RE: Advance to Construction Reevaluation
I-275 from S.R. 60 (Memorial Highway) to Himes Avenue
I-275 from Himes Avenue to Hillsborough River
Hillsborough County
Financial Project No: 258398-5 and 258399-2
Federal Aid Project No: Not Assigned Yet

**I-275 Segments 1A & 2A Advance to Construction Reevaluation-
Federal Highway Administration Comments and Responses**

Florida Department of Transportation
ADVANCE TO CONSTRUCTION REEVALUATION
 I-275 Segment 1A - FPN 258398-5
 From S.R. 60 (Memorial Highway) to Himes Avenue
 (Northbound and Southbound)
 I-275 Segment 2A - FPN 258399-2
 From Himes Avenue to Hillsborough River (Southbound)

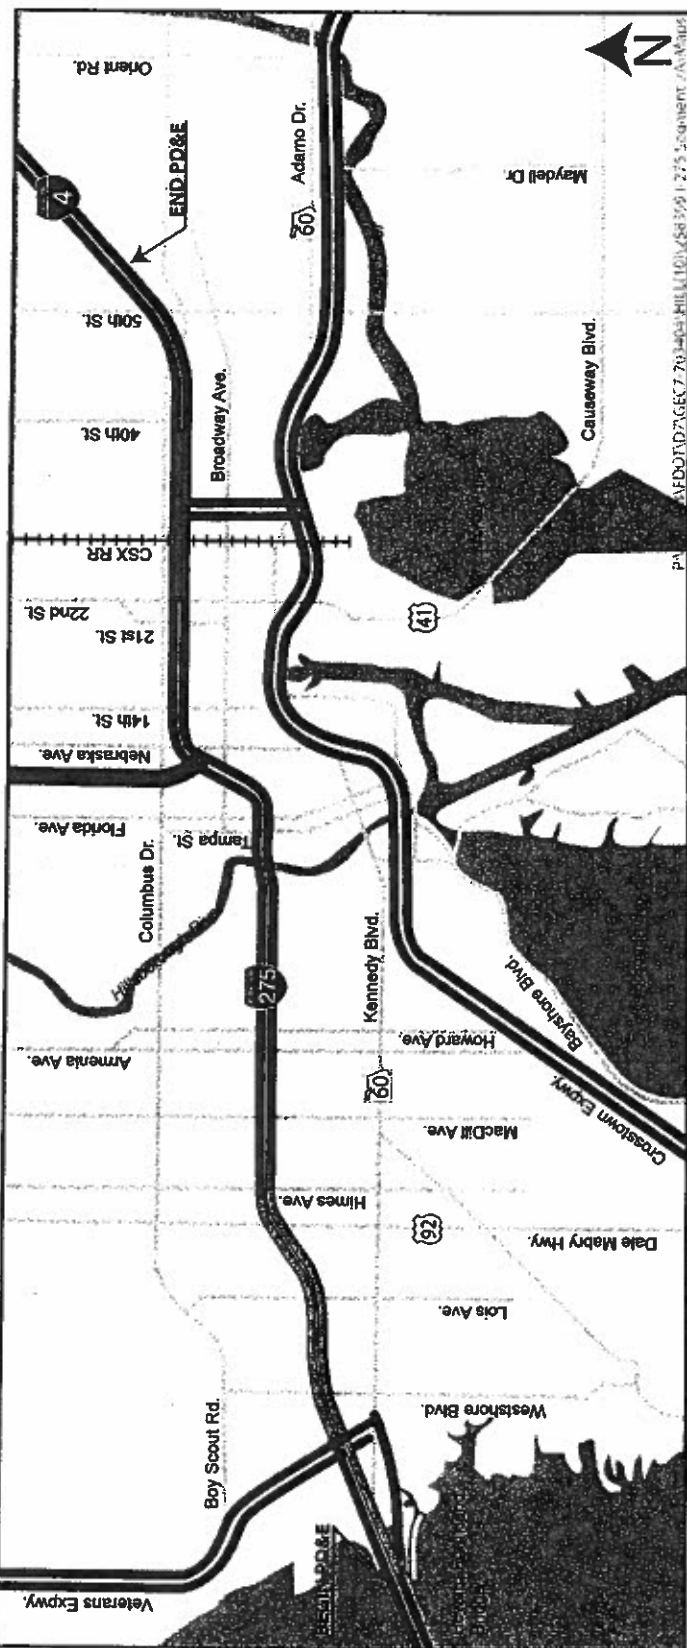
Comments Dated 4/16/09 via Memo from Marvin Williams	COMMENT ID	COMMENT	RESPONSE
	1	Can you supply an additional graphic that provides more detail on the series of design segments within the reevaluation area?	A set of the latest graphics are included with this reevaluation submittal.
	2	What is the status of the Level II contamination for both segments?	Level II Contamination reports have been finalized. Sites that require Level III remediation will be addressed prior to letting for construction.
	3	Are these projects consistent with the TIP & STIP?	Projects are included and are consistent with the TIP & STIP.

FPN: 258398-5
 FAP No.: Not Assigned Yet
 S.R. 60 (Memorial Highway) to Himes Avenue northbound and southbound
 Status: This Segment is the subject of this Advance to Construction Reevaluation
